October 17, 1985
ST-HL-AE-1427
File No.: G9.17

South Texas Project
Units 1 and 2
Docket Nos. STN 50-498, STN 50-499
Responses to DSER/FSAR Items;
Containment Leak Rate Test

<u>Attachment</u>	<u>Item No.*</u>	<u>Subject</u>
1	F 6.2-32	Figure 6.2.6-1, Containment Leak Rate Test Pressurization System

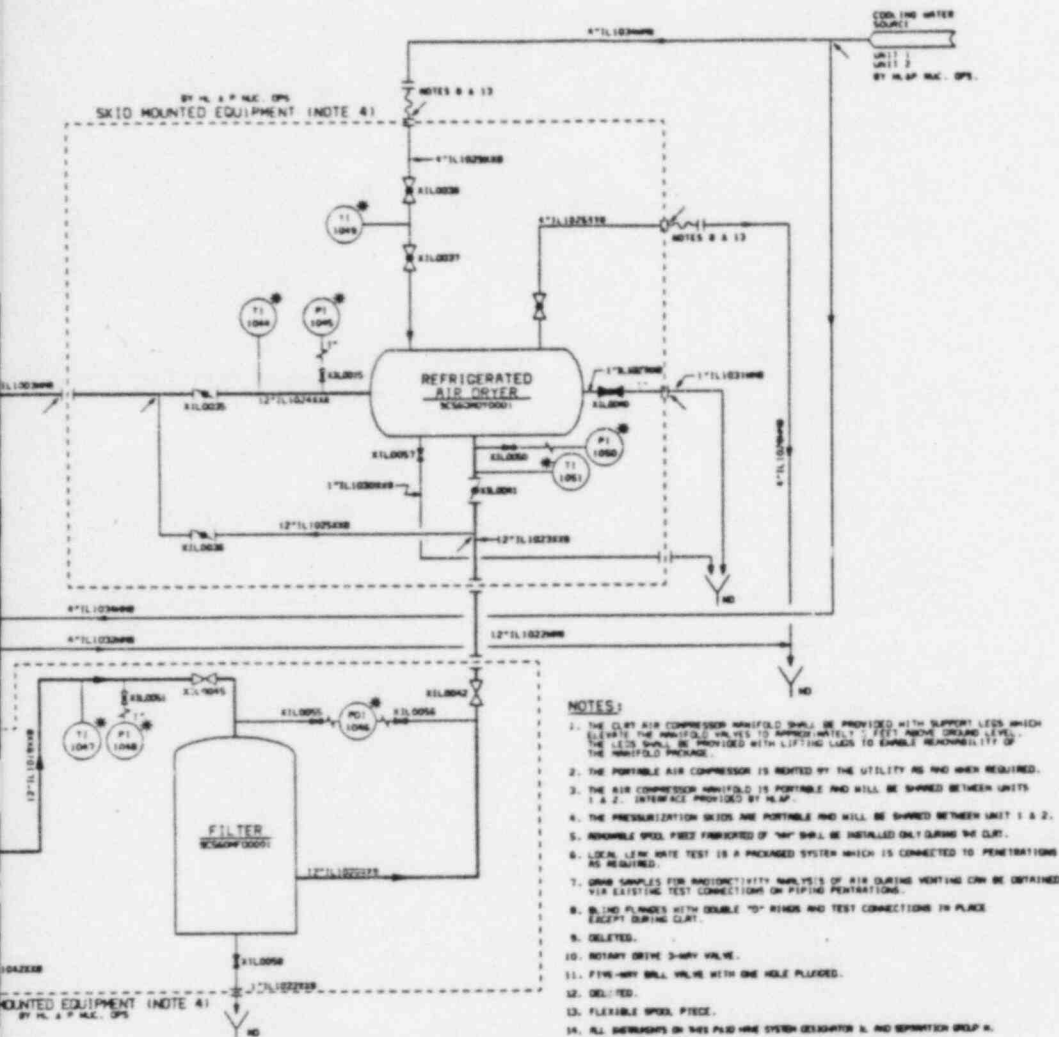
The attachments include mark-ups of FSAR pages which will be incorporated in a future FSAR amendment unless otherwise noted below.
